Date: March 24, 2025
To: All Prospective Bidders
From: Sam Li
Interim Director of Procurement Services
Re: Addendum Number 1
IFB # C1595R – Alumni Hall Reroof

PIPE OR CONDUIT SUPPORT

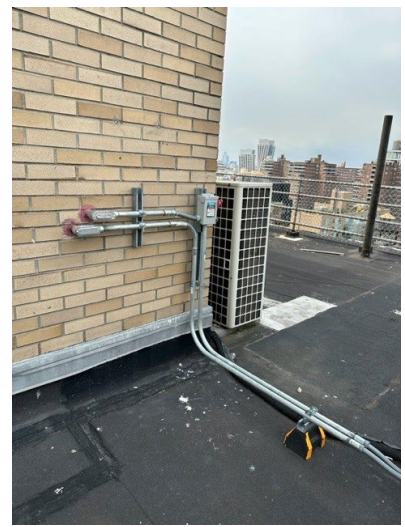
Q10. Keynote #22/A100.00 RELOCATE CONDUIT FROM FENCE TO RUBBER SUPPORTS ON TOP OF ROOFING. SEE DETAIL #10/A.801.00 FOR MORE INFORMATION (In given reference there is no detail for the rubber support)

A10. Keynote 22 specifically refers to rubberized pipe or conduit supports on the roofing system, which shall be reused. See A.100.00 for roof symbol legend and location of pipe or conduit supports. Detail #9 & #10/A.801.00 highlights the scope of conduit at the fence, which shall be relocated to the new guardrail as detailed. See Q11 for more information.

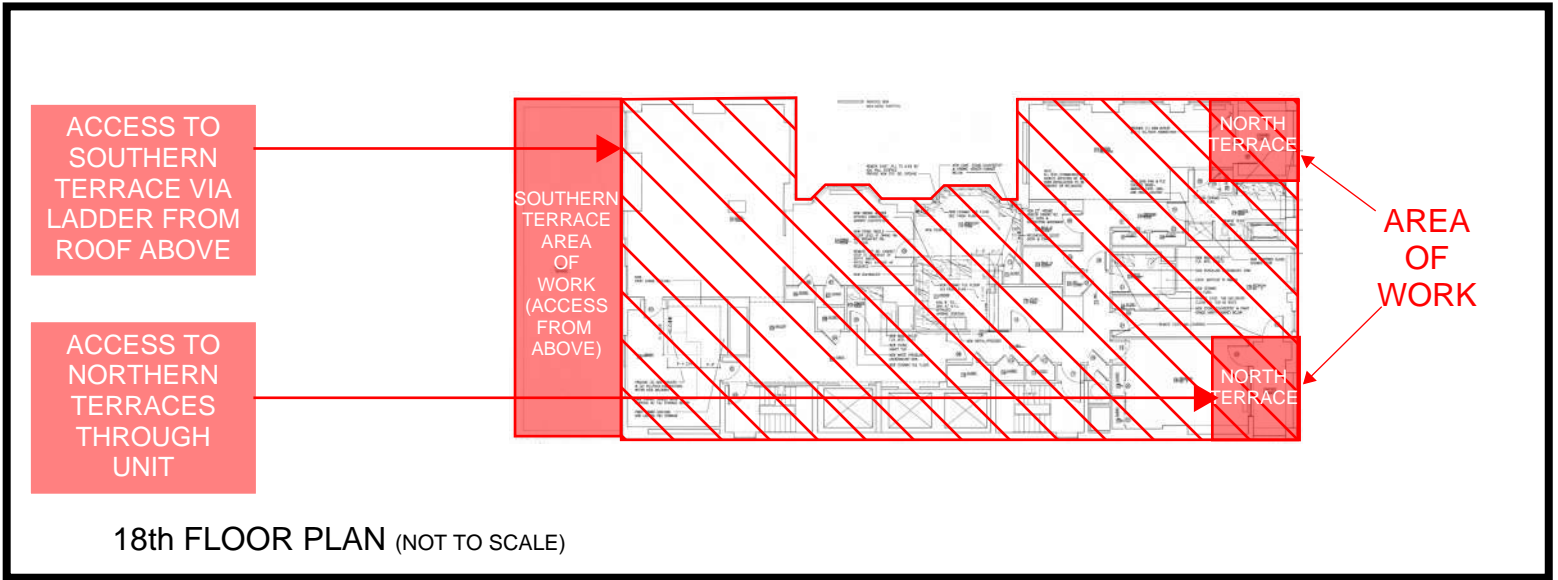
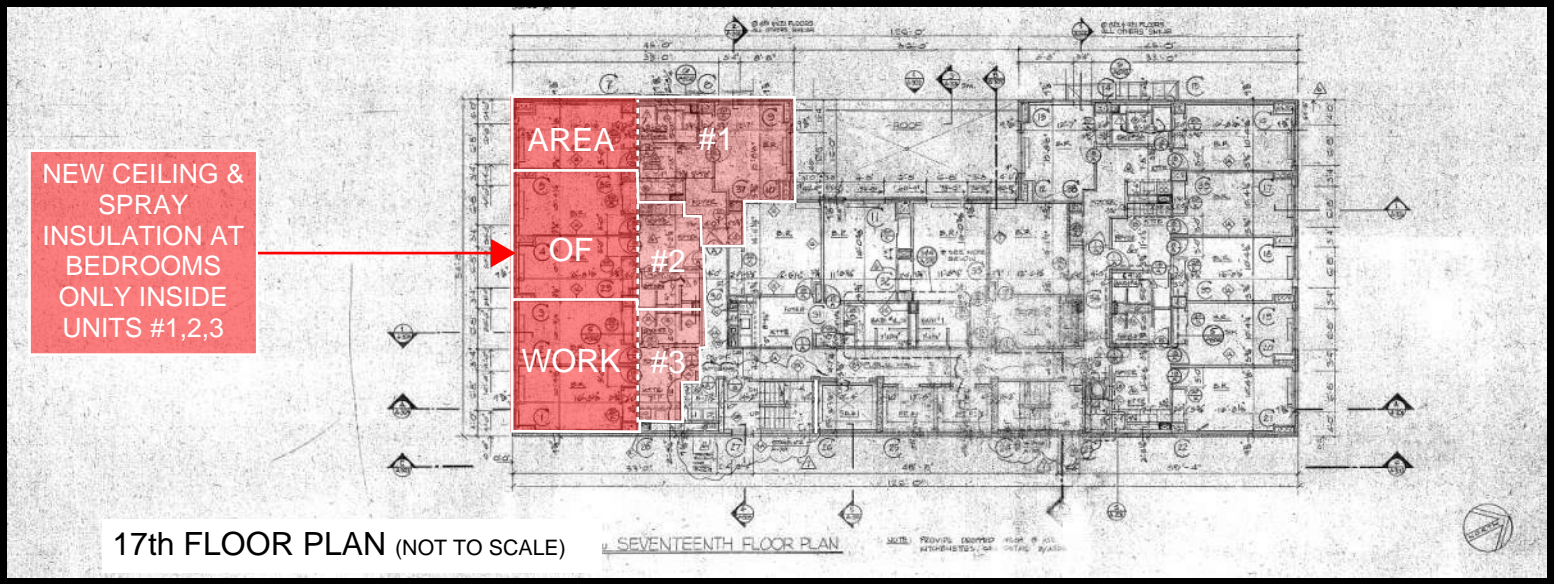
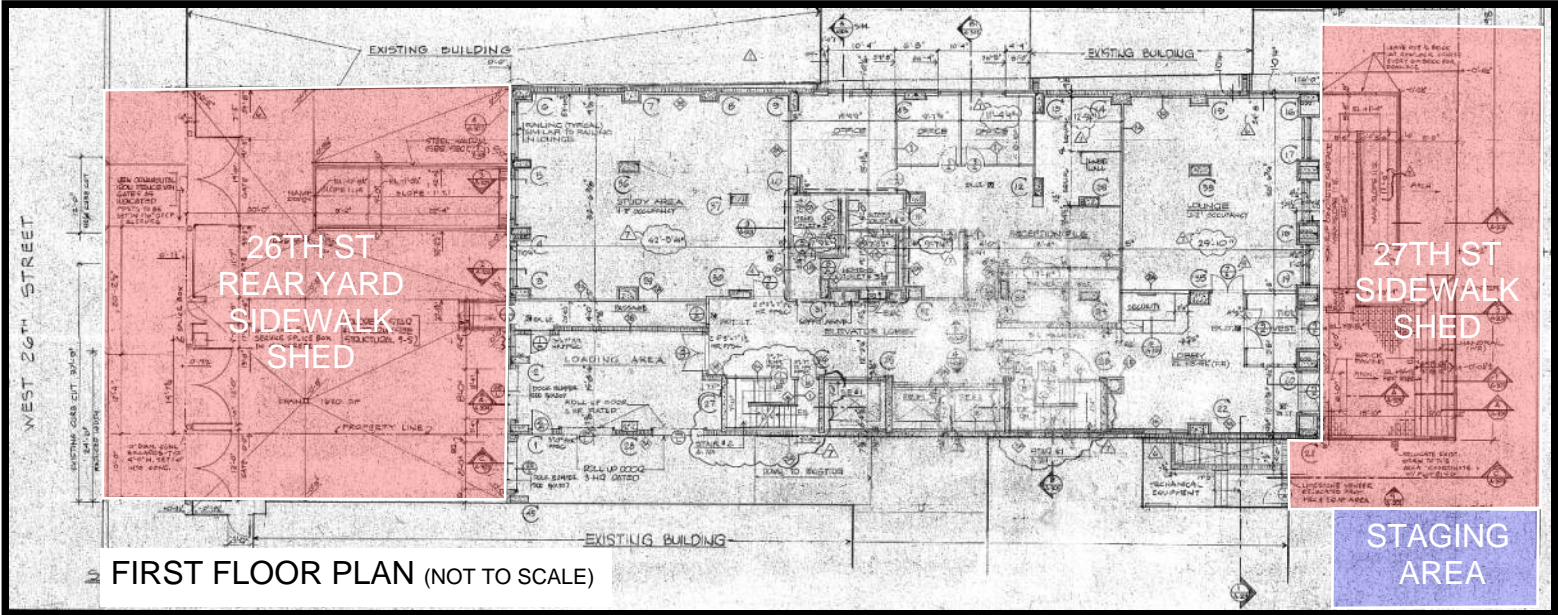
Q11. Section 10/A801.02 On top of section there is reference for KEYNOTE#2 (which is missing)

Q12. Section 10/A801.02 Provide elevation for the roof fencing.

A11. See note #2 on detail #10 / A.801.00. *(Note #2 is shown at the bottom of detail #10 / A.801.00).*
See Q10 for more information.

A12. Per Note #3, "Top of guardrail shall be a minimum of 3'-6" above the top of the roofing"
